TENNESSEE VALLEY AUTHORITY

November 7, 1985

TENNESSEE VALLEY AUTHORITY
WATTS BAR EMPLOYEE CONCERN PROGRAM
NUCLEAR REGULATORY COMMISSION
WEEKLY K-FORM LISTING

NONCONFORMANCE REPORTS OPENED PER MONTH

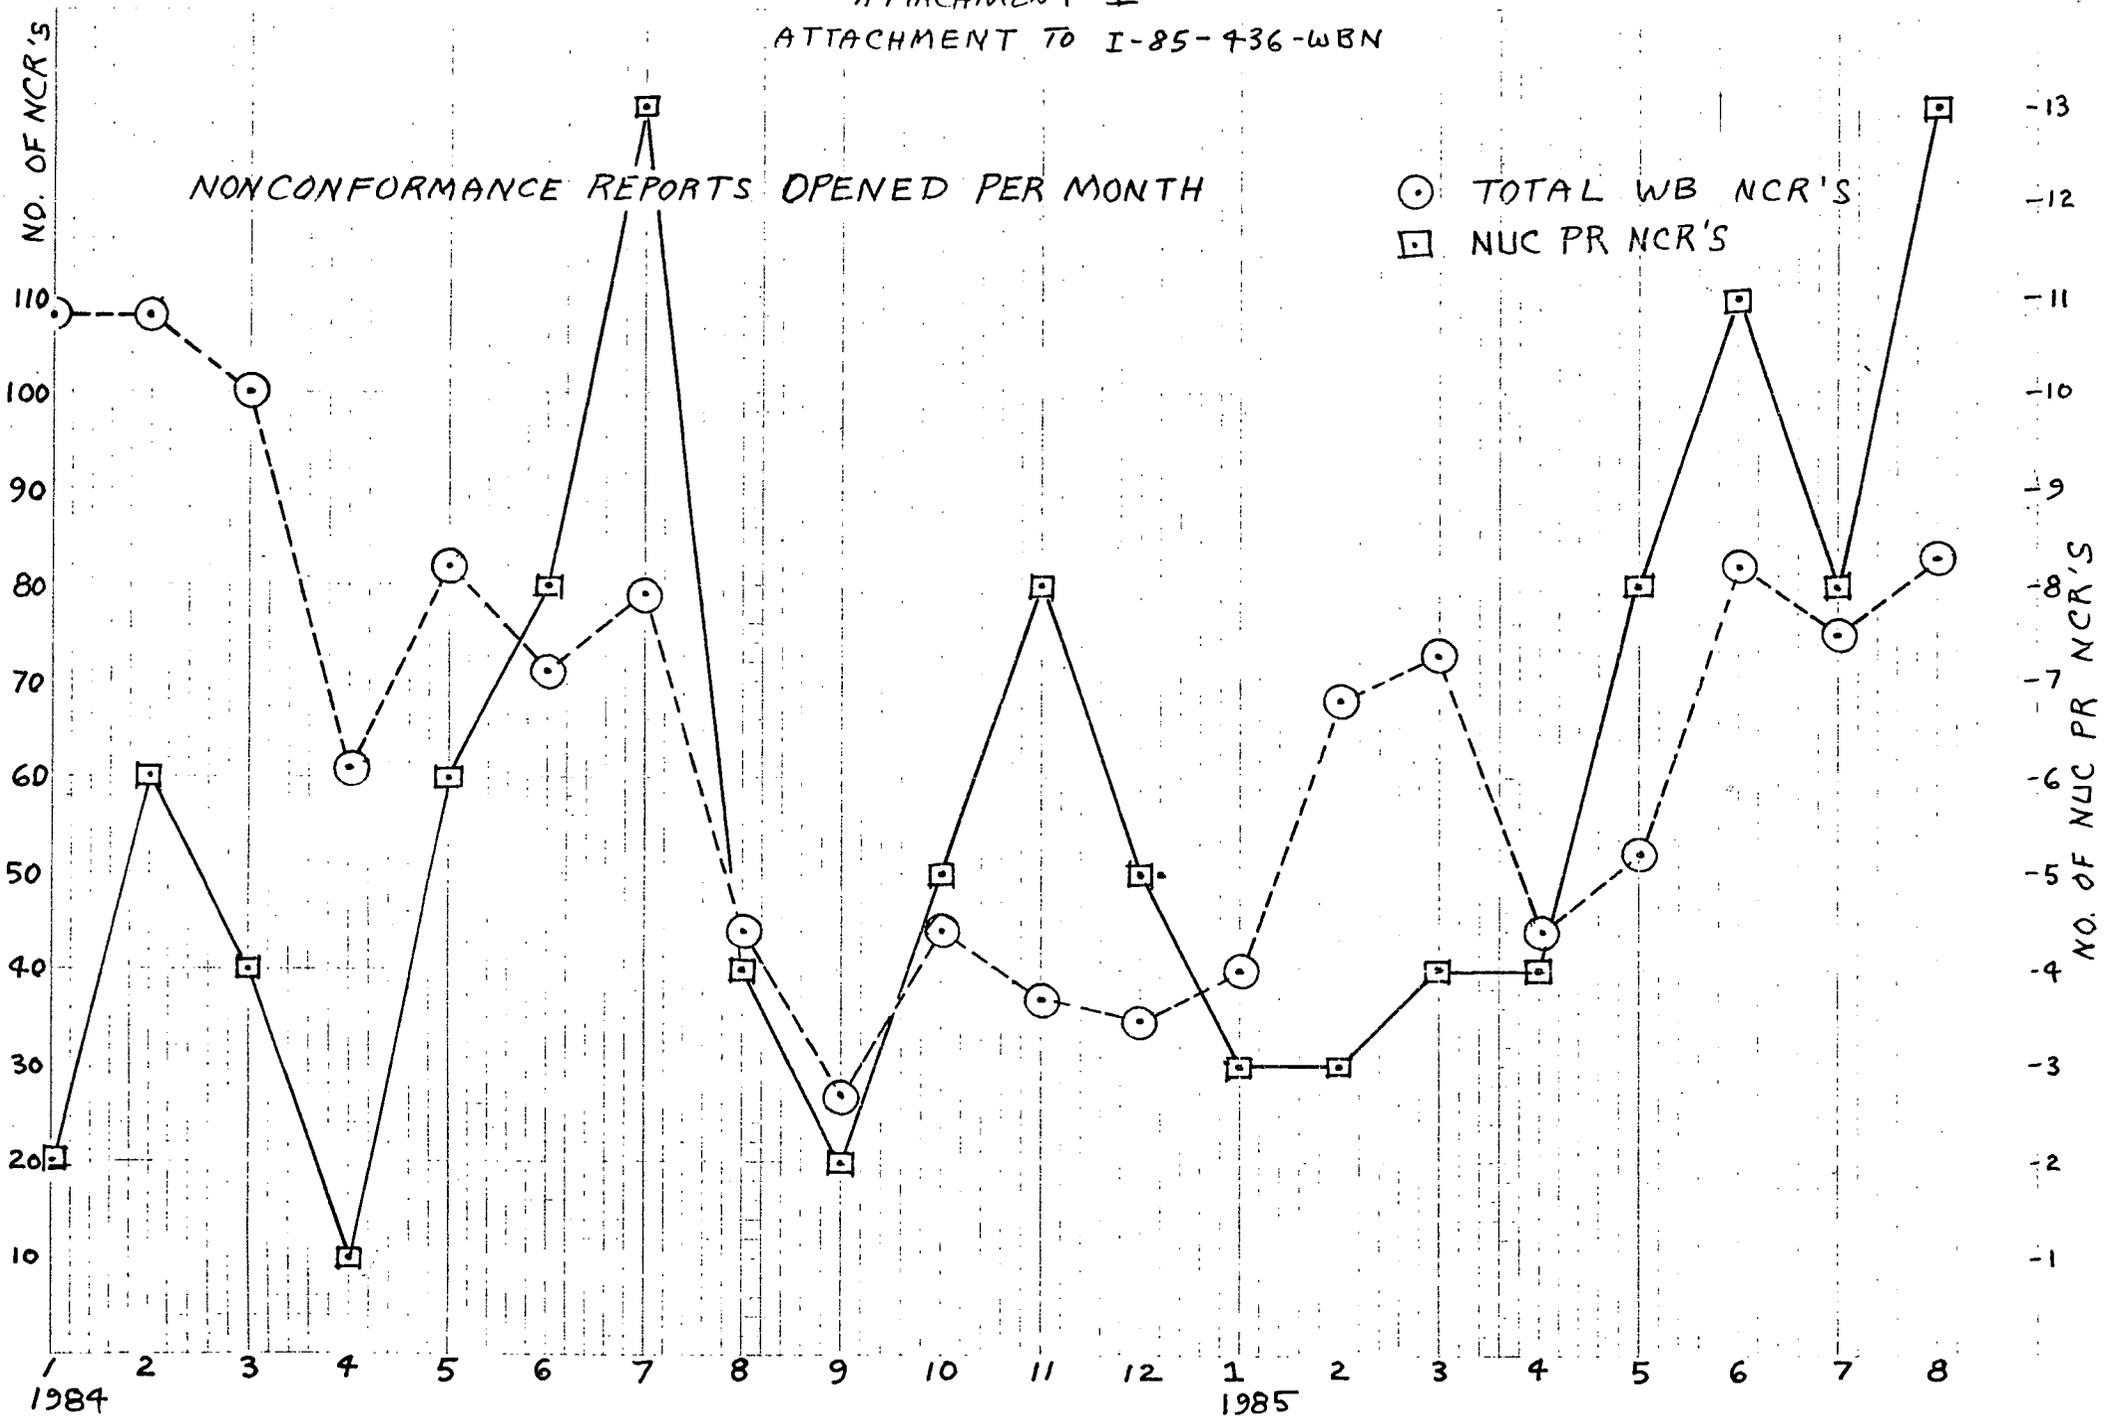
WBN procedures appear to minimize the role of the nonsupervisory employee in nonconformance reporting (NCRs). The only acknowledgement of nonsupervisory personnel in the process is a single statement, a "Note" in AI-2.8.3 that says: "Any cognizant plant personnel may initiate an NCR form if it is reviewed and approved by his appropriate section supervisor." This is in sharp contrast to the wording of AI-9.2 for maintenance requests. For example: "All plant personnel shall report the need for maintenance on plant equipment or systems by the use of a maintenance request. MRs may also be generated for performance of routine preventive maintenance or other activities, such as MI, SI, and workplan performance for documentation or tracking purposes. An MR may also be used to request the services of plant personnel."

Similarly, any employee can initiate a Corrective Action Report (CAR), and the employee can insist on issuance of a CAR over the objections of the plant manager (AI-7.3, section 5.4.3.3). By contrast, the supervisor must act as a determined sponsor to get an NCR through all the steps of AI-2.8.3 (see Attachment 4).

Revise AI-2.8.3 to allow any employee to initiate an NCR similar to the wording of AI-7.3 for CARs, including steps to take when the supervisor does not agree.
